**GREEN INTERNATIONAL AFFILIATES, INC.**

**Subject: Responses to Comments from Peer Review  
for The Preserve at Abbyville/Abbyville  
Commons Comprehensive Plan  
Dated July 27, 2017**

Exhibit 1  
Lots 52-55 Access

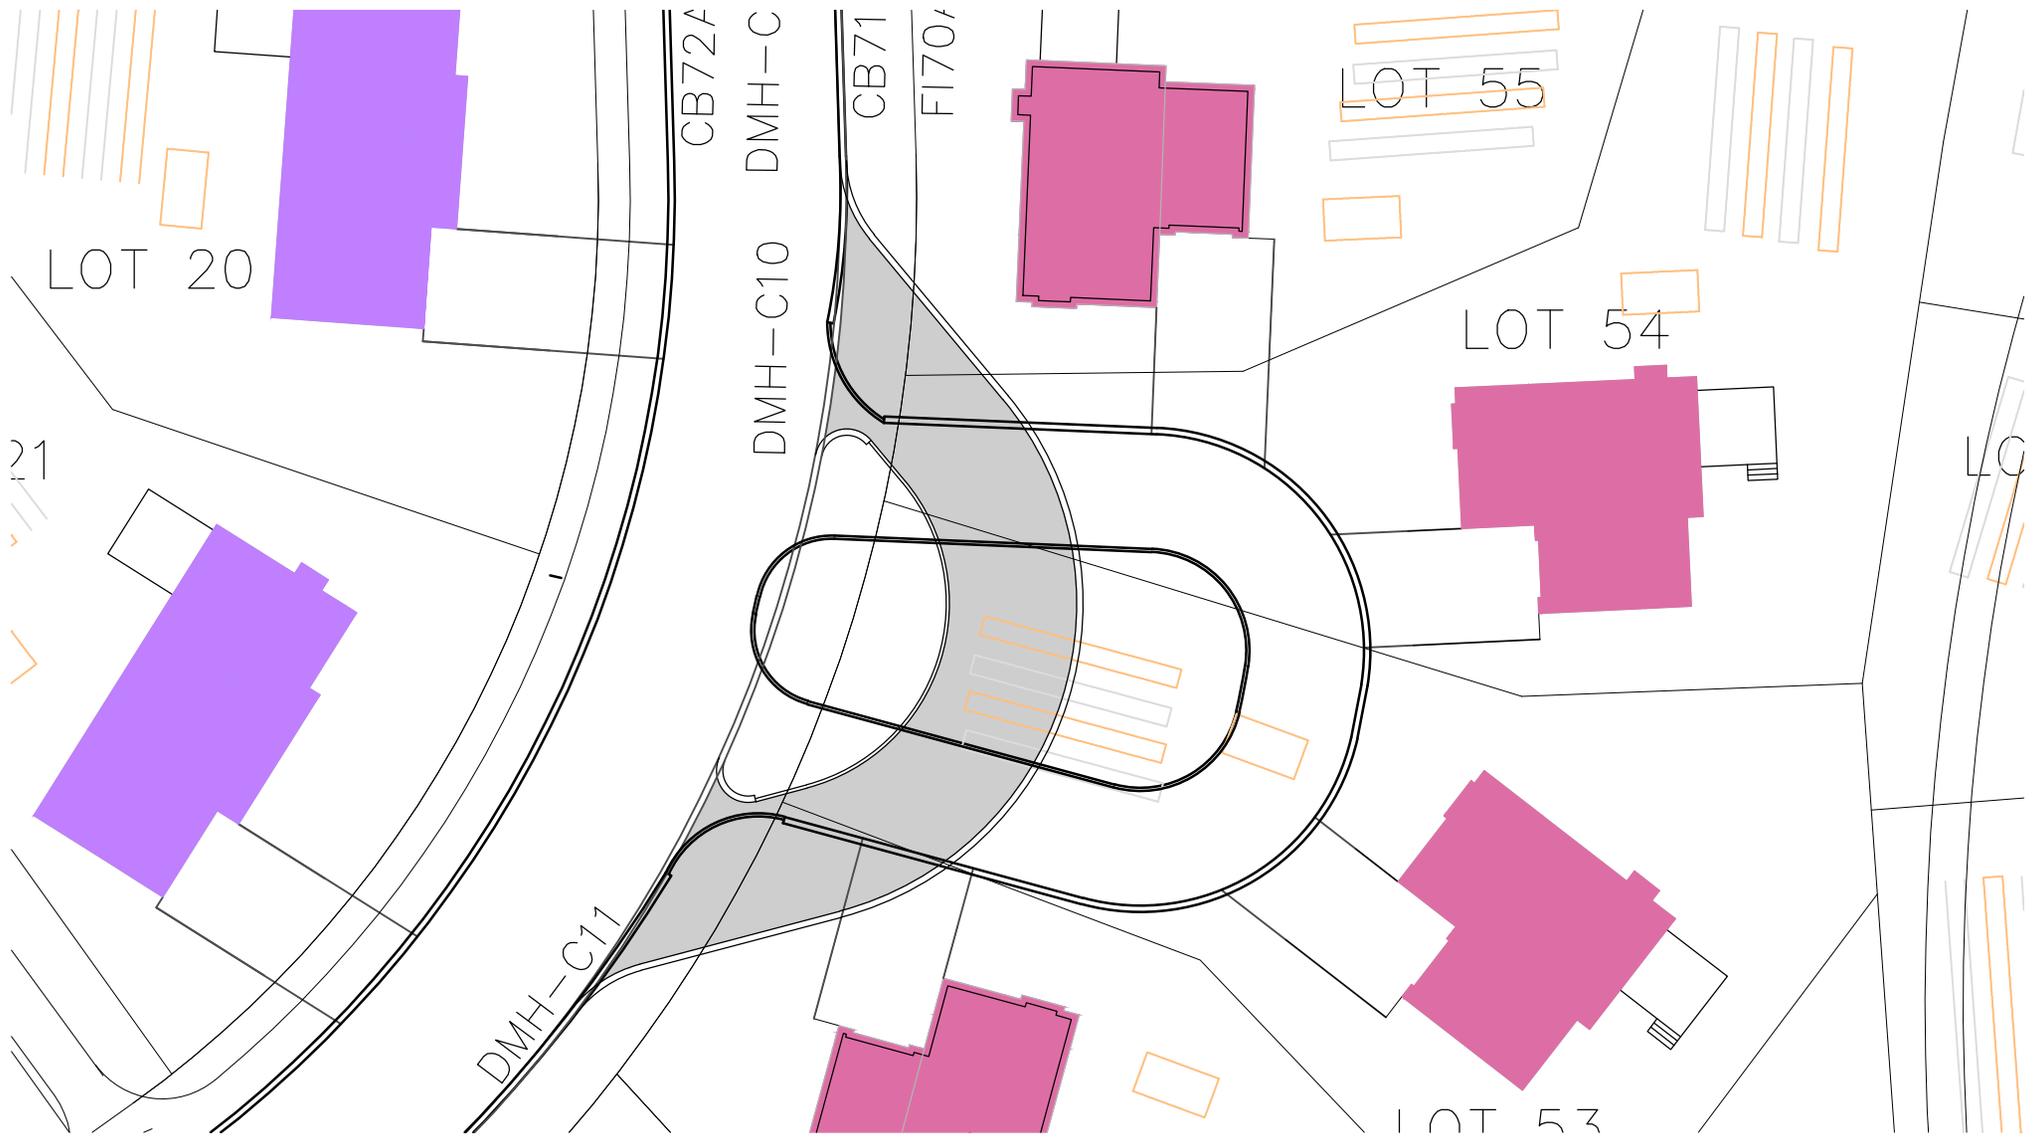
Horseshoes at Lots #52-55, Lots #56-58:

The outer corner path radius of the fire ladder truck's tightest turn is about 44' (for an 88.1' diameter). Hence, the radius of the horseshoes need to be at least 44.1' wide unless they are reconfigured to significantly flatten out the curves.

**Exhibit 3**  
Northern Roundabout

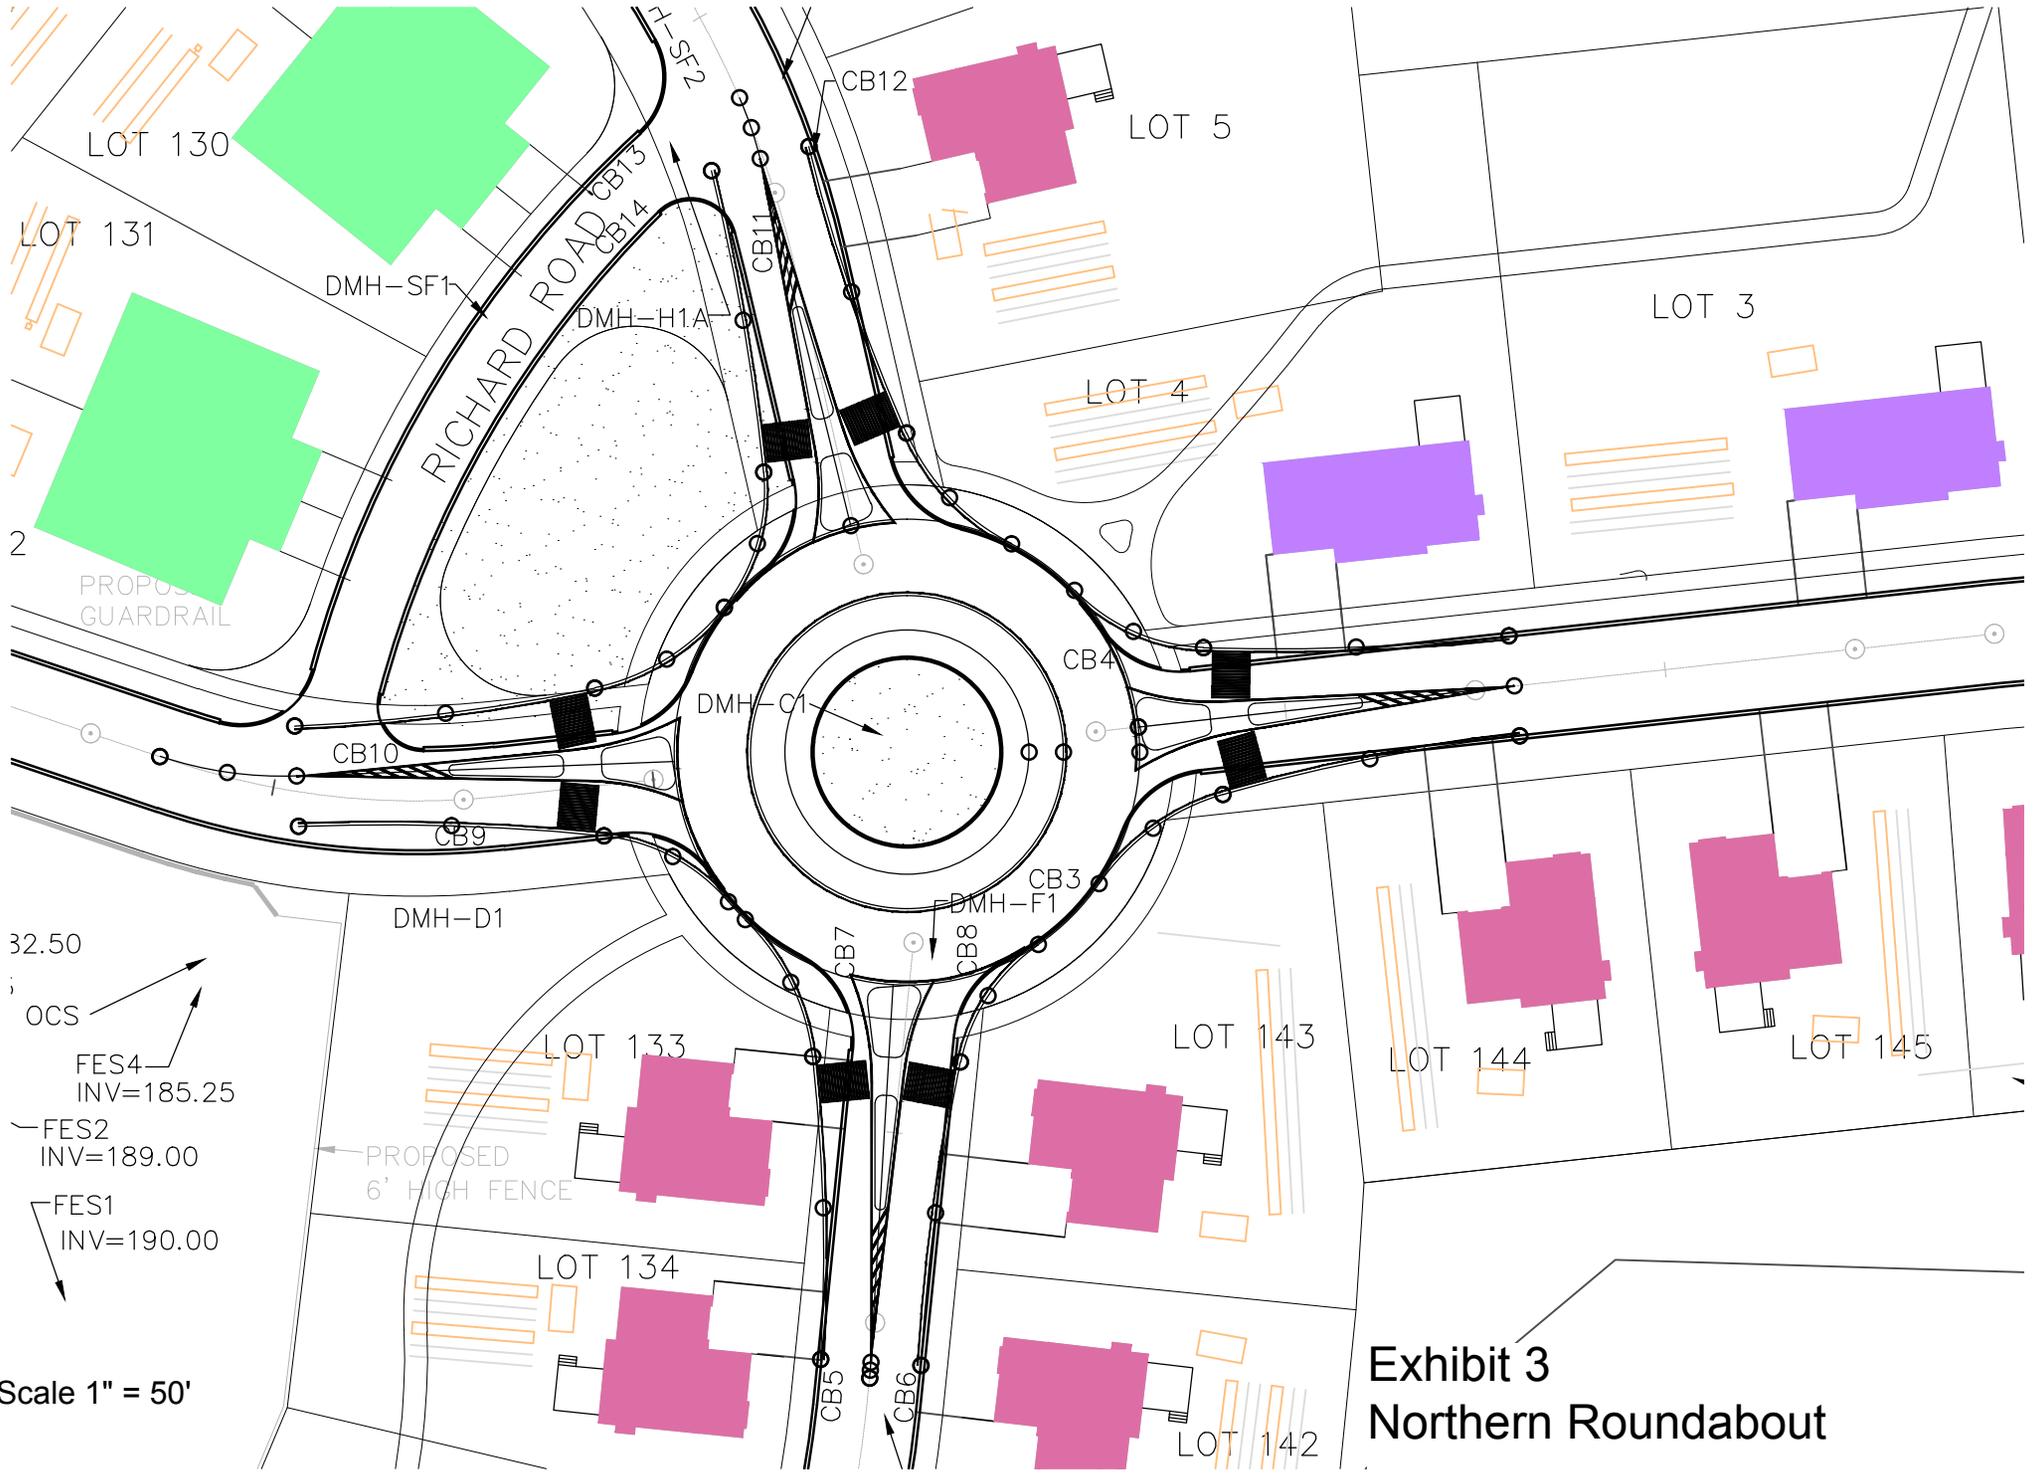
- 3. We will reserve additional comment [on roadway layout geometry for the internal roundabouts] until such time as we have had the opportunity to hear Green International's presentation at the August ZBA hearing, and will coordinate any resultant comments with the applicant/Green International.**

**Response:** Since the traffic reports and plans were first submitted and based on seeing the Beta comment, Green has conducted an analysis of internal turning movements of fire ladder trucks using AutoTurn software. As a result of our analysis, we have determined that the two circular intersections included in the initial plan submission could be modified to standard roundabout design without too much difficulty. We have provided to the site designer our recommended changes to these locations that would include splitter islands and center island apron. Fire apparatus has been tested with this design and is accommodated. Graphic depictions are attached while the site engineer will be submitting the revised plans under separate cover.
